Project Title: Regional Center Capital Improvements, GJRC Group Home A/C, FY 17-18

State of Colorado Project #2017-030P16

Bid Addendum #2 (Questions in Black, answers if Blue)

Demand Profile By Year

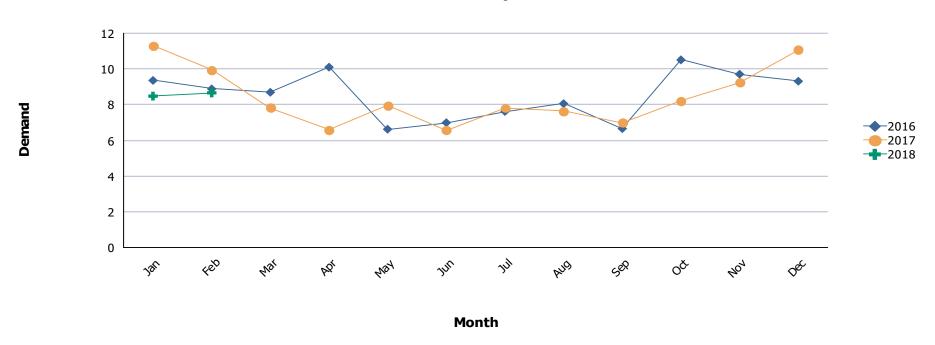
- 10. Can the owner provide the demand usage for last year at each location? This should be on the electricity bill statements. See above and attached electrical information.
